STAFF REPORT
(One-Step Final Plat, Deferred 10/2/08)

CASE NUMBER SUB 2008-68 -- LONG-HAYES COMMERCIAL ADDITION

LOCATION Southeast corner of 45th St North and Ridge (District V)

DRAINAGE & GRADING PLAN

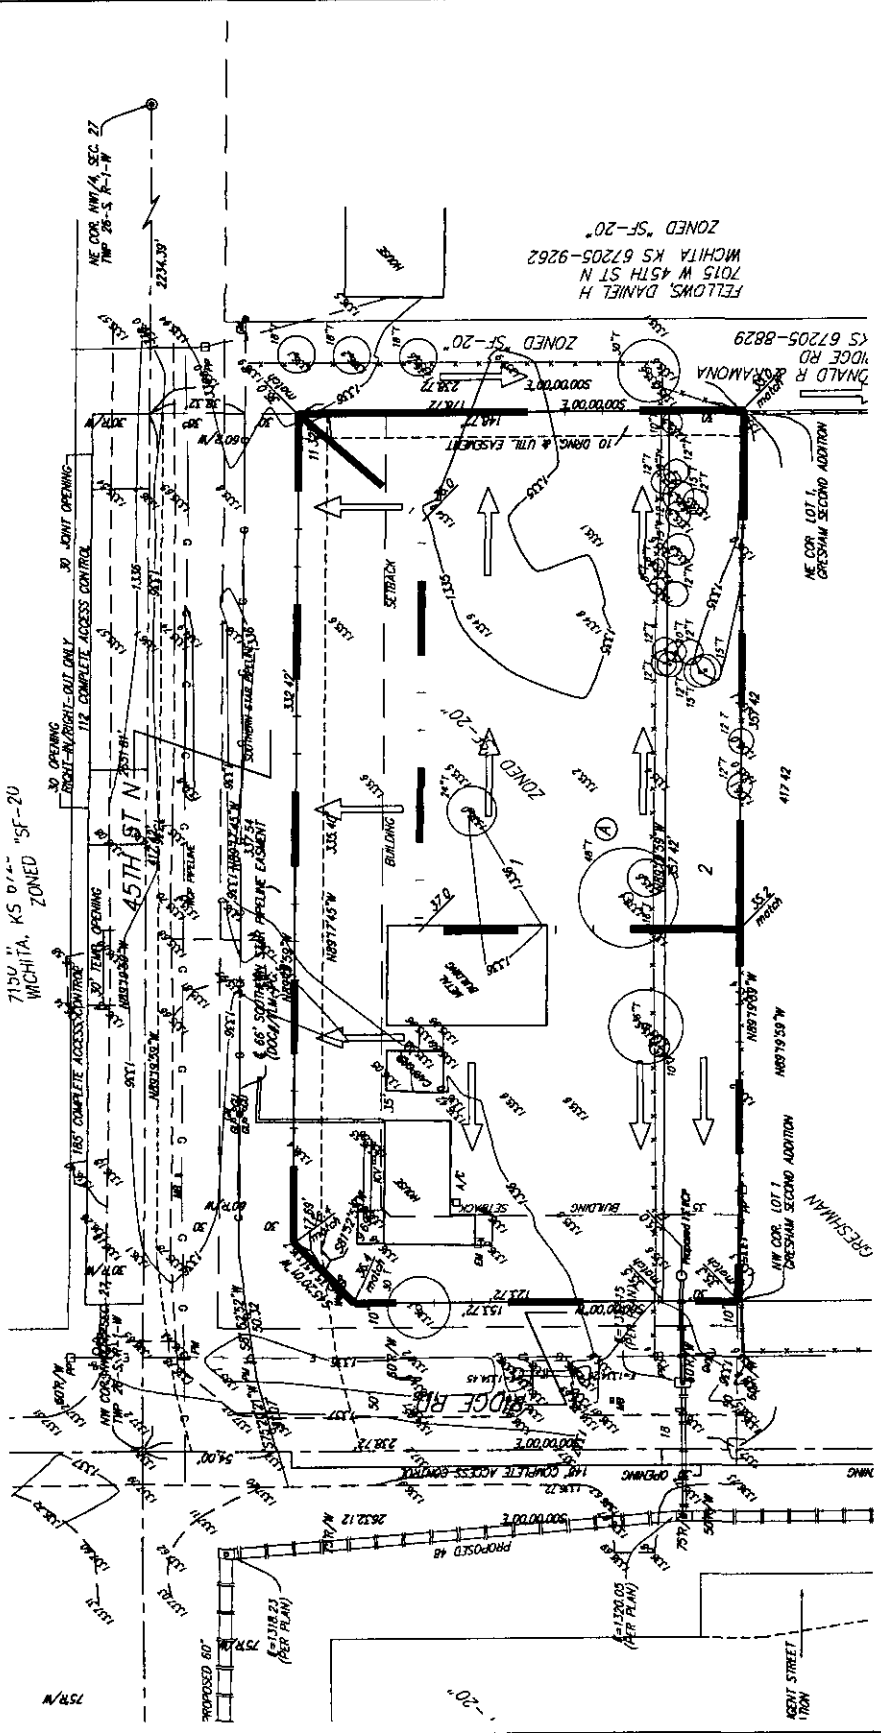
- D County Engineering needs to comment on the status of the applicant's drainage plan.
- E County/City Engineering have approved the access controls. The plat denotes two openings along 45th St North including a joint access opening with the property to the east. One opening along Ridge Road has also been denoted. The opening on Lot 2 shall be denoted as right-in, right-out only.
